COMMUNITY DESIGN REVIEW BOARD STAFF REPORT
Meeting Date November 15, 2022

REPORT TO: Melinda Coleman, City Manager
REPORT FROM: Elizabeth Hammond, Planner
PRESENTER: Elizabeth Hammond, Planner
AGENDA ITEM: Design Review, Residential Apartment Project, 3090 Southlawn Drive

Engineering Plan Review

SHEET NUMBER: **1** OF **2**
EXHIBIT 3. WETLAND BUFFER
EXISTING CONDITIONS
 PROJECT NUMBER: 0037066
 DATE: 10/24/2022

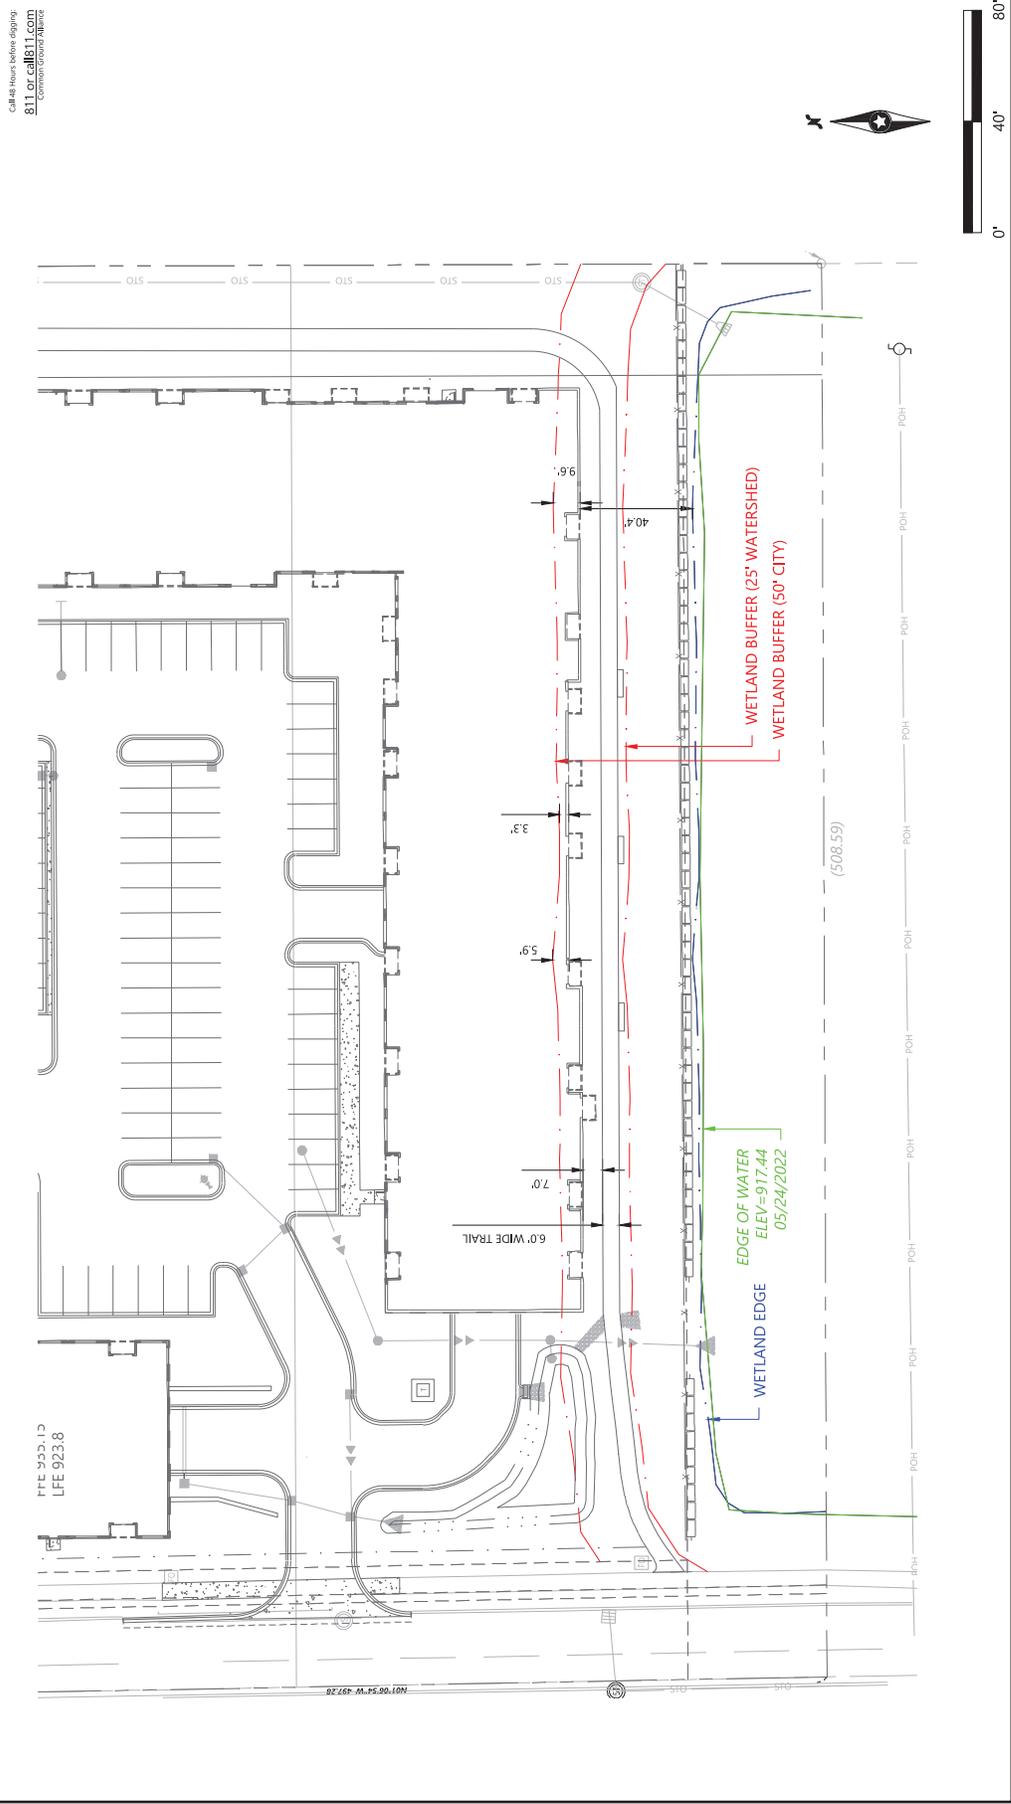
The existing structure, sidewalk, and surface parking have an approximate setback of 3' to 11' from the delineated wetland edge. A retaining wall north of the pond is in poor condition and in need of replacement due to structural instability. Existing vegetation is largely composed of invasive species and debris litters the pond's edge, as seen in the attached images.

EXHIBIT 3. WETLAND BUFFER PROPOSED CONDITIONS

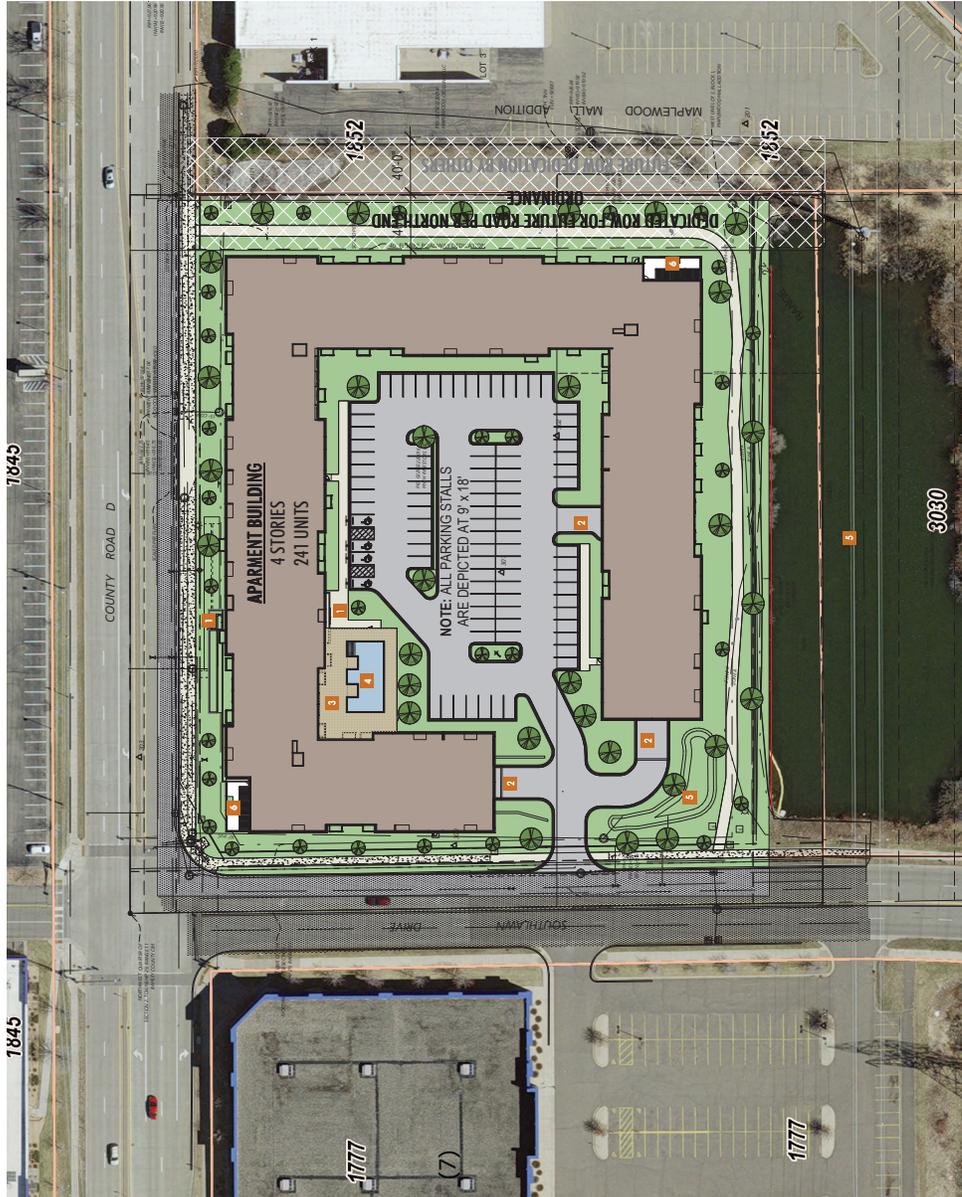
The proposed building will have an average 42.9' setback from the delineated wetland edge. The development proposes to remove and replace the existing structurally unstable retaining wall. Restoration of the southerly 25' within the wetland buffer with native vegetation will comply with the Ramsey-Washington Metro Watershed District requirements. This restoration will require grading activity within 3.3' of the delineated wetland edge to remove the existing pavement and building and establish the area with native vegetation.

In order to remove the existing building, sidewalk, surface parking lot, and retaining wall the applicants must grade up to the wetland, which will require a **50-foot wetland buffer variance**.

- a. Prior to issuance of a grading permit the applicant must:
 - 1) Submit a wetland buffer mitigation plan as follows:
 - a) Native Plugs: Include native plugs to be installed within the 25-foot re-established wetland buffer. Currently the landscape plan identifies a pollinator seed mix. Using plants rather than seeds hastens establishment and provides a better chance of successful establishment. The applicants should plant all plugs, or a mix of plugs and native seed mix in this area.
